**Meeting Date:** Tuesday 16 July 2013  
**Location:** Committee Room 2, Level 5, Civic Centre, 1 Devlin Street, Ryde  
**Time:** 5.00pm

**NOTICE OF BUSINESS**

<b>Item</b>	<b>Page</b>
1 CONFIRMATION OF MINUTES - Meeting held on 18 June 2013 .....	1
2 4 MAXIM STREET, WEST RYDE. LOT 5 SEC 3 DP 3646. Local Development Application for alterations and additions to the existing church. LDA2013/0096. <i>INTERVIEW 5.00PM</i> .....	6
3 461-495 VICTORIA ROAD, GLADESVILLE. Local Development Application for the construction of a new vehicular crossing at the intersection of Victoria Road & Tennyson Road, demolition of an industrial building & construction of a new ramp. LDA2012/0412. <i>INTERVIEW</i> .....	44
4 52 DARVALL ROAD, EASTWOOD. LOT 10 DP 13514. Local Development Application for the use of existing building as a secondary dwelling and outbuilding. LDA2013/100. <i>INTERVIEW</i> .....	84

Figure 2: Proposed car park within the front setback – non compliant with AS2890.6 and AS2890.1

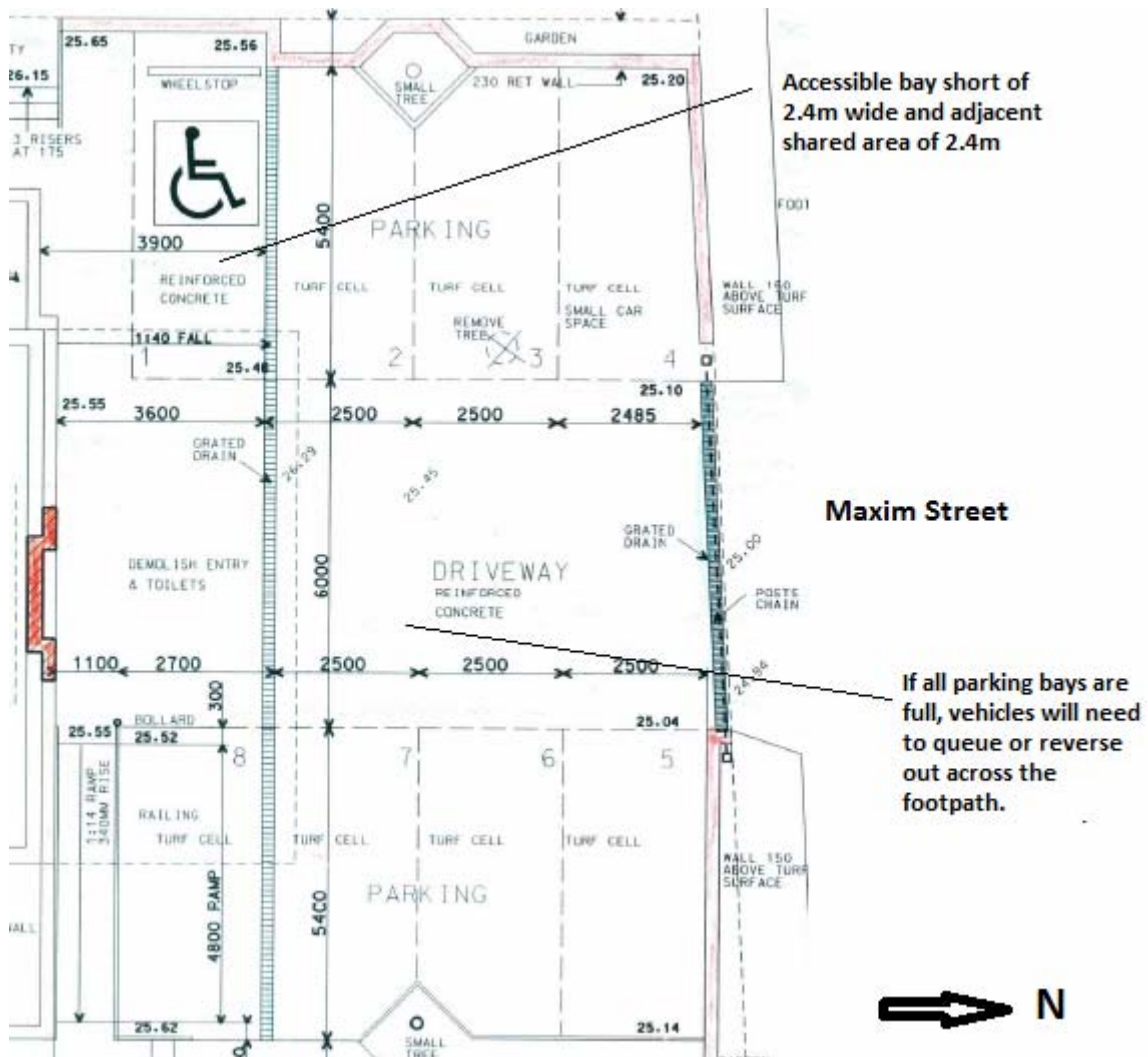
It is proposed to provide eight car parking spaces within the front setback with a centralised driveway, as shown in Figure 2 below. An accessible parking bay is located at the south-west end of the proposed car park area.

The proposed car park does not comply with above points (i) & (j) of the DCP. With the deferred commencement condition to amend the car park to enable on site landscaping to screen and soften the front car park, the proposal will satisfy point (j). With regard to point (i), recent changes made on 1 March 2013 to the *Environmental Planning and Assessment Act 1979* reinforced that, the provisions contained in a DCP are not statutory requirements and are for guidance purposes only. Whilst the car park will be located within the front building setback, the amended car park will provide for on-site landscaping, sufficient width for the accessible car park bay, and remove the use of turf cells. These amendments will provide for a sensible planning outcome and satisfy the objectives of the zone, as such the proposed variation to Clause 3.2 (i) could be supported by Council.

1. **Car Park.** The front car park is to be amended to delete the use of turf cells and two car parking spaces. The two car spaces on either side of the front driveway are to be deleted and the car park amended to comply with AS2890.6. The amended design is to maximise the storage space/control point for queuing on entry to the site so as to minimise queuing across the footpath. The amended car park should provide deep soil planting and landscaping to minimise and screen the visual impact of the car park from the public domain. A Landscaping Plan with details of the front fence, type/schedule of planting proposed is to be submitted. The proposed planting are not to restrict sightlines for pedestrian and vehicles entering/exiting the site. Details of the amended car park/layout and the landscaping plan are to be submitted and approved by Group Manager Environment and Planning.

2. **Driveway** - The driveway is to be amended to be provided at 90 degree to the kerb to provide for safe access to the car parking area, as required under Part 8.3 of DCP 2010. The amendment to the driveway would necessitate the relocation of the existing street tree. Details of the amended driveway, relocation of the street tree and planting of another street adjacent to the side of the driveway, are to be submitted and approved by Group Manager Environment and Planning.

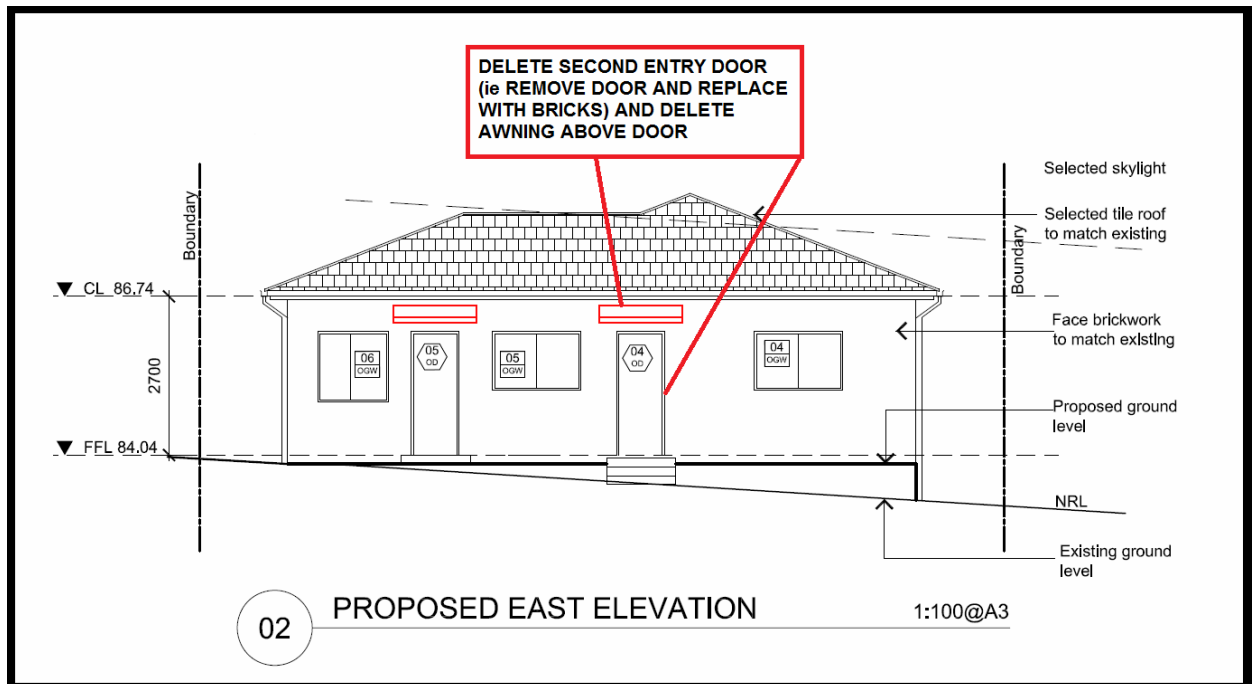
- Block up the windows to the north elevation (i.e. remove windows and replace with bricks to match the existing bricks), noting that the outbuilding already has two other windows to the eastern side. See condition 1(c) in Attachment 3. See also diagram below:

- Block up and remove the second entry door to the eastern side (i.e. remove door and replace with bricks, delete awning above this door), noting that the outbuilding already has an entry door on the southern side. See condition 1(d) in Attachment 3. See also diagram below:
